Field Service Bulletin

Bulletin No:	TASC_CROSS-CONNECT_06_01
Date Issued:	Dec, 13 2006
Product Effected:	TASC_Cross-Connect Interface

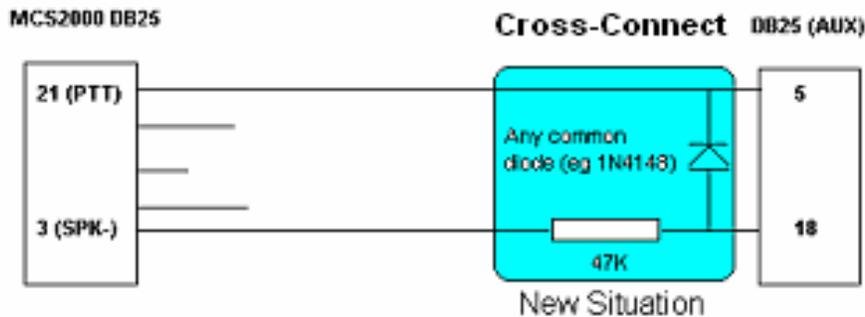
However, if the system is operating in full duplex mode and using simplex radios, system instability can occur if exact simultaneous access attempts are made from both sides of the system or if at that same time both systems are busy transmitting.

What will occur is both radios, after attempting to be keyed up by the Cross-Zone Interface as a result of receive activity at its COR radio inputs, will sound the Call Deny tone, which in turn causes the system to respond as though both COR outputs are activated. This leads to a key up attempt of "the other" radio that causes a closed loop which can only be broken by powering down one of the composing elements (i.e. either Cross-Zone Interface, or either radio).

This potential lock up condition can be eliminated by a small modification to the cable connecting the Cross-Zone DB25 Port A / AUX port. Essentially, this modification ensures that the radios COR cannot be active when the radio's PTT input has been activated, thus opening the loop and eliminating the lock up condition.
